**SUBDIVISION, PLANNING APPROVAL &
SIDEWALK WAIVER STAFF REPORT****Date: November 6, 2014****NAME**

Rangeline Crossing Subdivision

LOCATION5289 Halls Mill Road
(East side of Halls Mill Road, 230'± North of Rangeline Road, extending to the North side of Rangeline Road and the West side of Demetropolis Road)**CITY COUNCIL
DISTRICT**

Subdivision approval to create two legal lots of record, Planning Approval to allow a truck maintenance facility in a B-3, Community Business District, and Sidewalk Waiver to waive the construction of a sidewalk along Halls Mill Road.

SITE PLAN

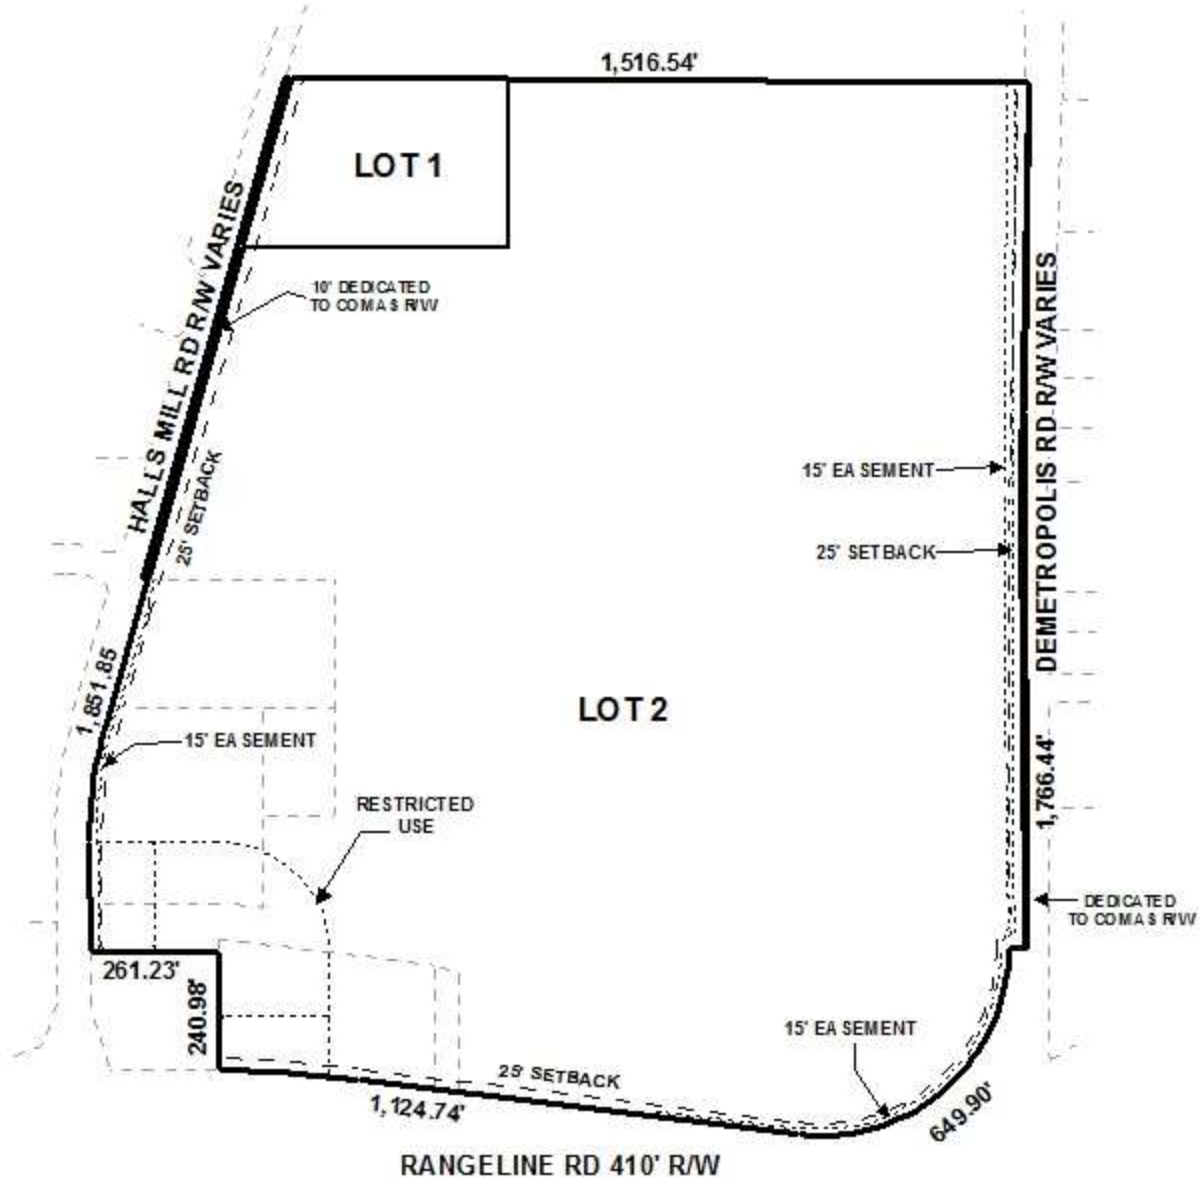
The plat illustrates the 25' minimum building setback line along Demetropolis Road as measured from the required frontage dedication. However, there is a 15' water and sewer easement slightly further within the property along that street frontage. Therefore, the plat should be revised to illustrate a minimum building setback line along Demetropolis Road as necessary to also include this easement and measured from the required dedication. As shown in other areas of the site, the 25' minimum building setback line should also be illustrated along all street frontages as measured from any required right-of-way dedication.

As on the preliminary plat, the lot sizes should be labeled on the Final Plat in both square feet and acres, after any required right-of-way dedication, or a table should be furnished on the Final Plat providing the same information. Lots, common areas, and a restricted use parcel, all recorded with Halls Mill Crossing Subdivision, would be eliminated and those areas would become part of Lot 2.

As submitted, the plat contains a note and signature block for County Engineering. County Engineering no longer signs Subdivision plats where the subject property is fully within the City limits of Mobile; therefore, this note and signature block should be removed from the Final Plat.

- 4) revision of the plat to illustrate a minimum building setback line along Demetropolis Road as necessary to also include the 15' water and sewer easement, as measured from any required right-of-way dedication;

- 5) retention of the 25' minimum building setback line along all other street frontages as measured from any required right-of-way dedication;
- 6) retention of the labeling of the lot sizes in both square feet and acres on the Final Plat, or the furnishing of a table on the Final Plat providing the same information;

- 7) completion of the Subdivision process prior to the issuance of any permits for the development of either lot;
- 8) removal of the County Engineering note and signature block from the Final Plat;

DETAIL SITE PLAN

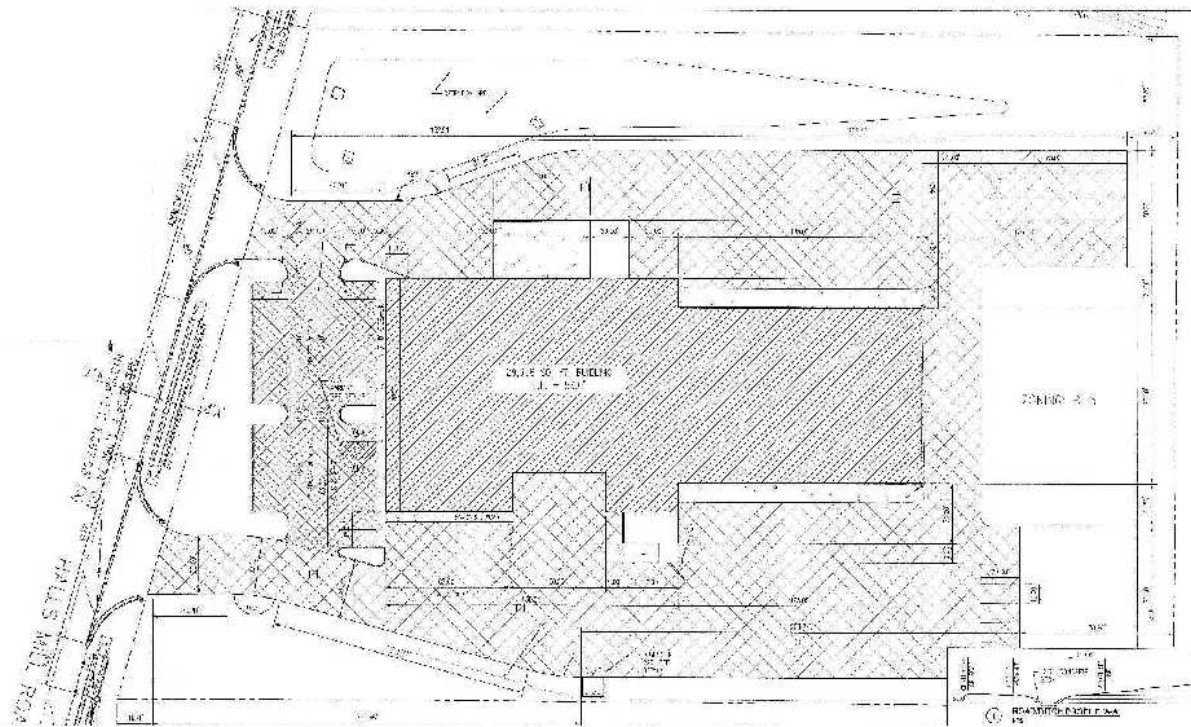
The site plan indicates a proposed 29,338 square-foot building with associated parking and landscaping areas. As presented, the parking calculations should be rounded up to indicate 25 parking spaces required for office use, with a total of 31 spaces required for the office and warehouse/service area uses. The site plan does not provide property boundary dimensions. Therefore, the site plan should be revised to provide the dimensions of the property lines.

Landscaping and tree planting calculations indicate compliance with the requirements of the Zoning ordinance. It should be noted that all parking, landscaping and tree planting calculations were provided via a separate sheet; therefore, the site plan should be revised to include these calculations.

As the site has approximately 357' of linear street frontage, the allowance of two curb cuts as indicated on the site plan would be in order. The site plan indicates the curb cut widths to be approximately 35' to allow for semi truck ingress and egress. Therefore, the curb cut widths should be coordinated with Traffic Engineering. As no sidewalk is indicated on the site plan, and as an associated Sidewalk Waiver is requested, should the Waiver be denied, the site plan should be revised to indicate a compliant public sidewalk along Halls Mill Road.

As the site is proposed to have more than 25 parking spaces, lighting of the entire site to comply with Sections 64-4.A.2. and 64-6.A.8 of the Zoning Ordinance would be required, which will require the submission of a photometric plan at the time of application for a land disturbance permit.

- 1) revision of the site plan to include parking calculations to be rounded up to indicate 25 parking spaces required for office use, with a total of 31 spaces required for the office and warehouse/service area uses;

- 2) revision of the site plan to provide the dimensions of the property boundaries;
- 3) revision of the site plan to include the landscaping and tree planting calculations;

- 4) placement of a note on the site plan stating that the site is limited to two curb cuts to Halls Mill Road with the location, size and design to be approved by Traffic Engineering and conform to AASHTO standards;

- 5) revision of the site plan to indicate a City standard sidewalk along Halls Mill Road should the Sidewalk Waiver be denied;
- 6) lighting of the entire site to comply with Sections 64-4.A.2. and 64-6.A.8 of the Zoning Ordinance, which will include the submission of a photometric plan at the time of applying for a land disturbance permit;
